**RE: ODOT Garage Site Plan Review**

The City of Massillon Engineering Department has reviewed the submitted site plan for the above referenced project. The following comments have been compiled for the site plan. I did not create a redline mark up set. **In your re-submittal provide a response letter addressing each comment and three (3) revised sets of plans and if applicable two (2) copies of supporting documentation.**

## STANDARD DROP MANHOLE

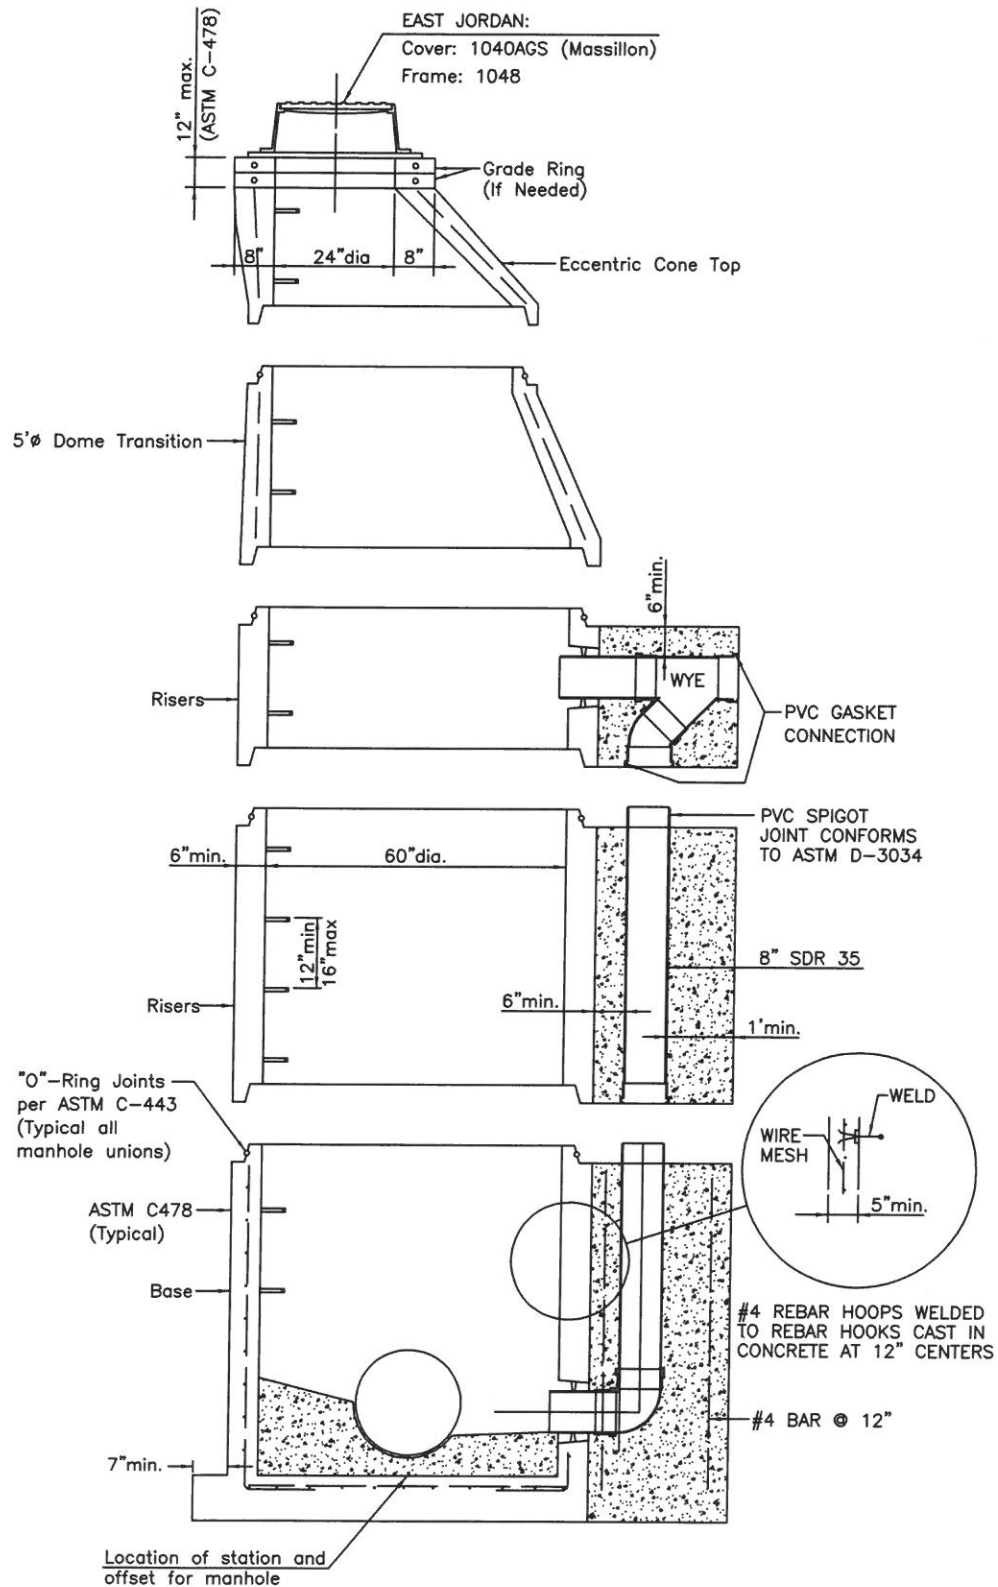
- 20) Provide a detail for the sanitary outside drop manholes on the plans (see attached)
- 21) Provide City of Massillon driveway detail on the plans (see attached)
- 22) Provide City of Massillon sewer testing notes on the plans (see attached)
